Date: 07.02.2020

Russell Hobbs Microwave Oven - Product Modification Notice

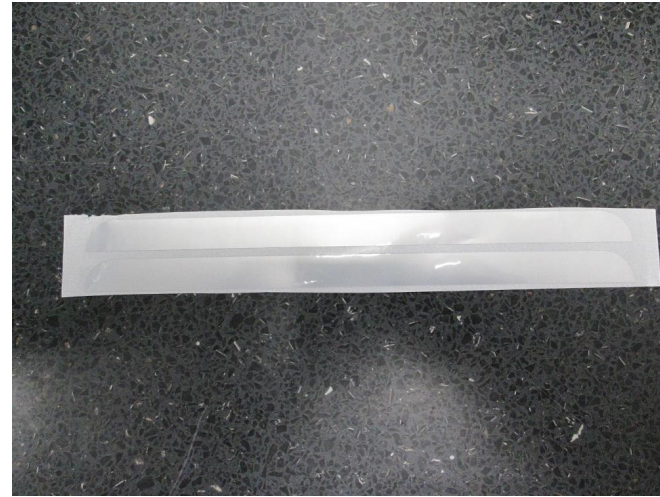
In a small number of instances, it has been identified that the door on the Russell Hobbs microwave has rubbed against the frame of the unit during transit which has caused a level of cosmetic abrasion in the process.

As a demonstration of our commitment to customer satisfaction a simple modification to the microwave has been developed, in conjunction with our component supplier, to prevent any future problems of this nature. This involves the fitment of two additional protective adhesive strips to the interior of the microwave door (please see attached fitting instructions for more information).

To apply the protective strip the following process needs to be followed

Firstly, open the microwave door and ensure all surfaces are clean from grease.

Apply one strip at a time to the inside of the microwave door as shown below.

Remove one protective strip at a time from its backing paper.

Ensure the protective strips are aligned correctly to the outer edging as shown in the image below.
